MLC School Rowing Program  
Rowley Street  
Burwood NSW 2134

14 November 2019

**Re SSD 8924 - New Sydney Fish Market Concept and Stage 1 Early Works**

**Appendix 1:** Incorrect diagram of the rowing course as drawn in the EIS

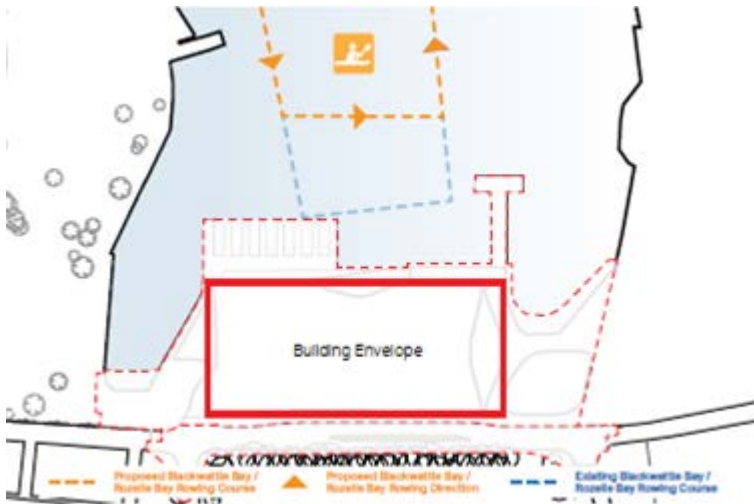
We recognise compromise in a complex project like this is required, but the correct impact on the rowing course of the current design of the East wharf plan is much greater than currently noted and creates an unnecessary safety risk. This is not helped by the omission of Glebe Rowing Club and its pontoon from most of the major relevant diagrams including those in A3 Vol Appendix 1 Concept Drawings and A3 Vol Appendix 2 Concept Design Report Part 3.

We currently muster and turn where the Eastern Wharf is planned to end. Even with a reduced rowing route, we estimate that our turning circle would put us directly in front of the new wharf. When including ferry services likely to be placed at the front of the wharf, rowing boats would be mustering around 20m from the wharf.

We request that the wharf be shortened by at least 25m to restore the safe distance from the actual turning circle of boats and the wharf.
